Work Order ID 101584

Item Name: Crosstube Aft

DRAWING NO. D412-664-243	TITLE CROSSTUBE ASS'Y (412 HI AFT)	REV. E	DART AEROSPACE LTD ENGINEERING ORDER		D.E.O. NO. D412-664-243-E-2	SHEET NO. SHEET 1 OF 1	SCALE NTS
DRAWN 9P	CHECKED ASS	MFG. APPR. ER	APPROVED MP		DE APPR. TH		
DATE 11.09.07	DATE 11.09.19	DATE 11.09.19	DATE 11.09.19		DATE 11.09.19

DRAWING NO. D412-664-243	TITLE CROSSTUBE ASSEMBLY (412 HI AFT)	REV. E	DART AEROSPACE LTD ENGINEERING ORDER		D.E.O. NO. D412-664-243-E-4	SHEET NO. SHEET 1 OF 3	SCALE NTS
DRAWN 92	CHECKED A	MFG. APPR. A	APPROVED MP		DE APPR. MP		
DATE 12.08.21	DATE 12.08.30	DATE 12.08.30	DATE 12/8/30		DATE 12.08.30

**D412-664-243
ASSEMBLY DETAIL**

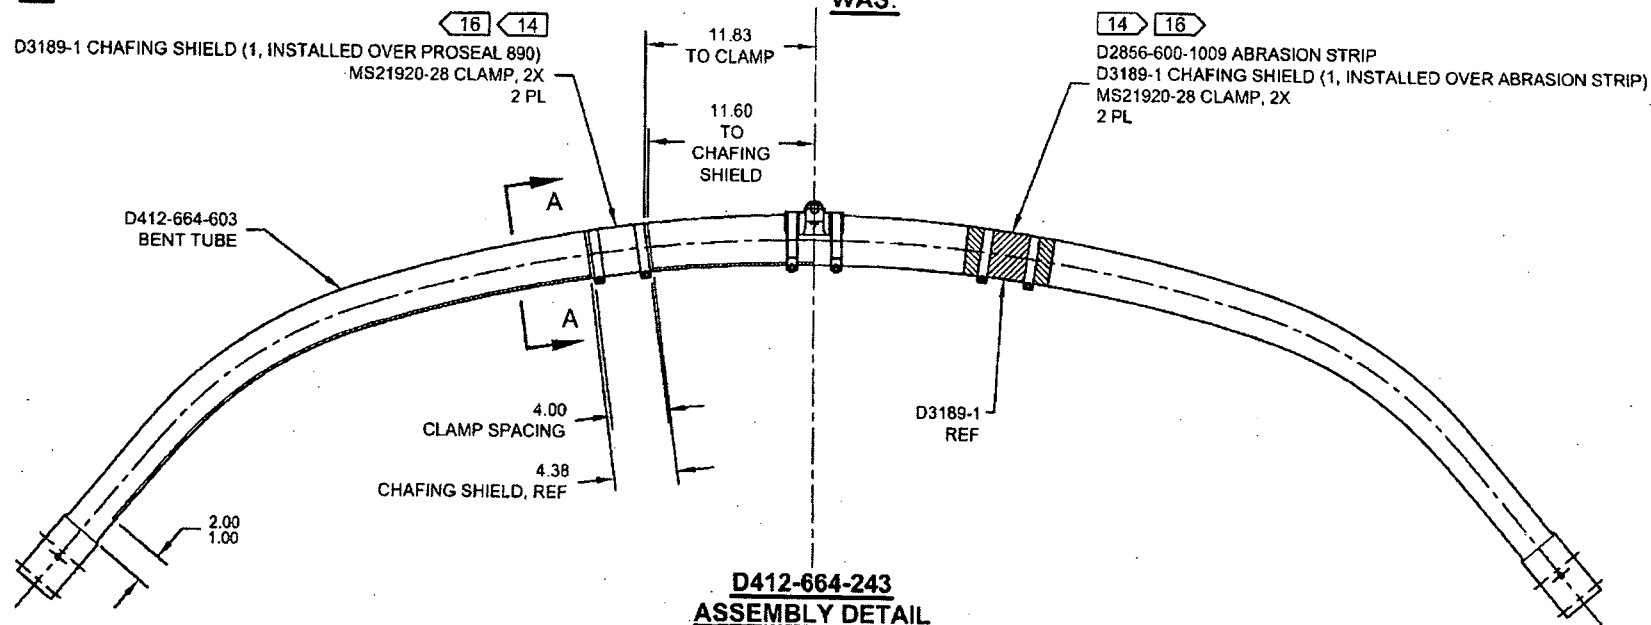
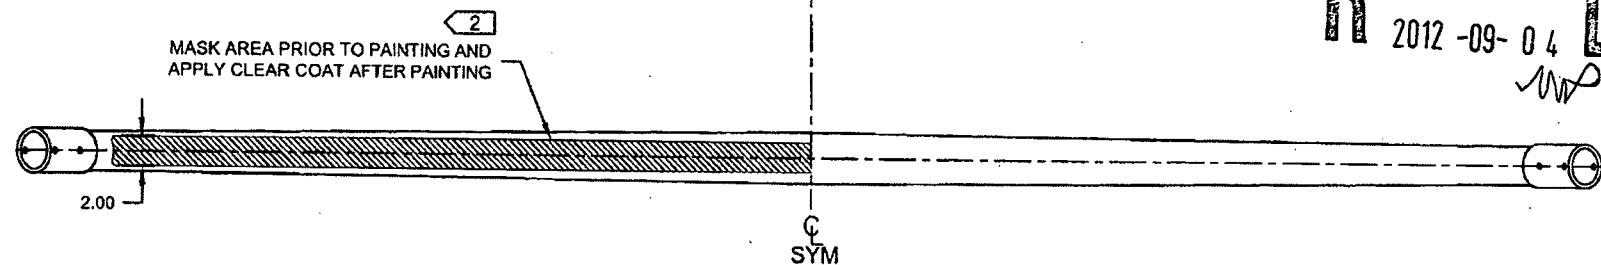
D3189-1 CHAFING SHIELD (1, INSTALLED OVER PROSEAL 890)
MS21920-28 CLAMP, 2X
2 PL

WAS:

D2856-600-1009 ABRASION STRIP
D3189-1 CHAFING SHIELD (1, INSTALLED OVER ABRASION STRIP)
MS21920-28 CLAMP, 2X
2 PL

SECTION A-A
CHAFING SHIELD DETAIL
VIEW ROTATED, NOT TO SCALE

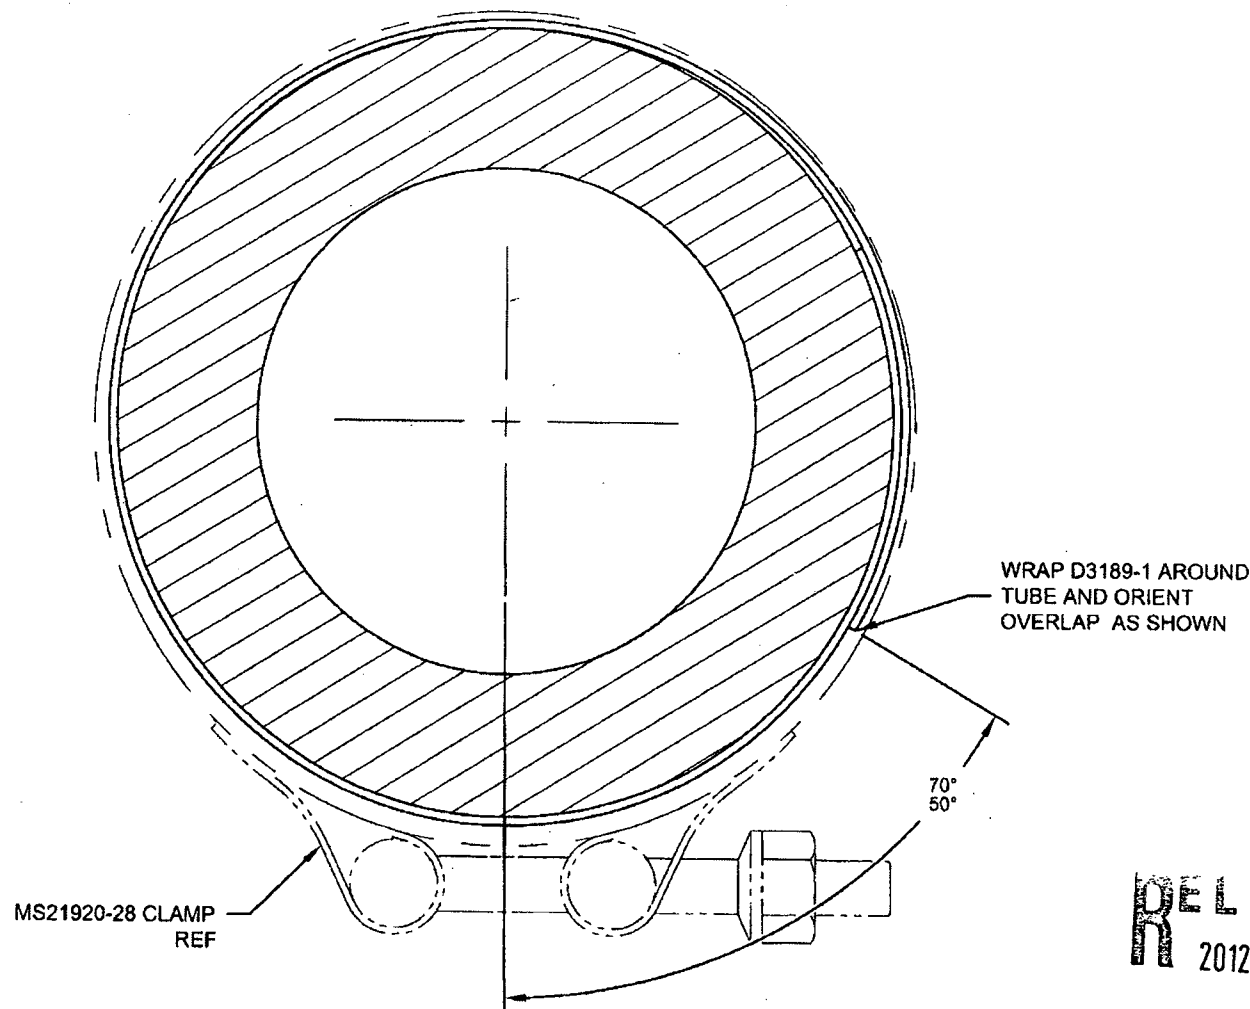
NOTES 2, 14, AND 16 ON SHEET 1 ARE AMENDED AS FOLLOWS:
